Access Compliance Report

Public Rights-of-Way (Curb Ramps)

Intersection ID: 53044	Main Street: MELODY_WOODS_CT	Cross Street: WILLOW_OAK_RD	Location: SW
ADA ID: 4B6EC88018CC	Ramp Type: Para	Initial Pass/Fail: Fail	Overall Compliance: No
Codes/Mitigation Info/Possible Solution		Field Measurements/Component Compliance

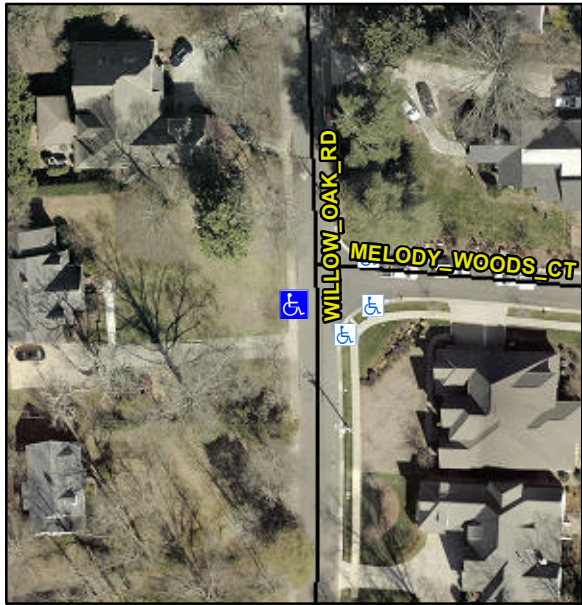
R304.5.1, R304.5.3

Compliance	Description	Data	Compliance	Description	Data
N/A	Ramp Length LT (in)	74.0	N/A	Ramp Length RT (in)	72.0
No	Ramp Width LT (in)	38.0	No	Ramp Width RT (in)	38.0
Yes	Ramp Slope LT (%)	6.3	Yes	Ramp Slope RT (%)	7.3
No	Ramp XSlope LT (%)	3.1	Yes	Ramp XSlope RT (%)	0.2
N/A	Landing Length (in)	N/A	N/A	DWS Provided?	N/A
N/A	Landing Width (in)	N/A	N/A	DWS Contrast?	N/A
N/A	Landing Slope (%)	N/A	N/A	DWS Length (in)	N/A
N/A	Landing X Slope (%)	N/A	N/A	DWS Full Width?	N/A
N/A	Landing Curb? (Y/N)	N/A	N/A	DWS Offset (in)	N/A
N/A	Shared Landing?	N/A			
N/A	Gutter Ponding?	N/A	N/A	Gutter Slope (%)	N/A
N/A	Gutter Lip Ht (in)	N/A	N/A	Gutter X Slope (%)	N/A
N/A	Painted X Walk1?	No	N/A	Painted X Walk2?	N/A
	X Walk 1 Direction	To E		X Walk 2 Direction	N/A
N/A	X Walk 1 Width (in)	N/A	N/A	X Walk 2 Width (in)	N/A
	X Walk 1 Slope (%)	4.5		X Walk 2 Slope (%)	N/A
	X Walk 1 X Slope (%)	0.8		X Walk 2 X Slope (%)	N/A
N/A	Ramp inside XWalk1?	N/A	N/A	Ramp inside XWalk2?	N/A

Remove & Replace Entire Ramp.
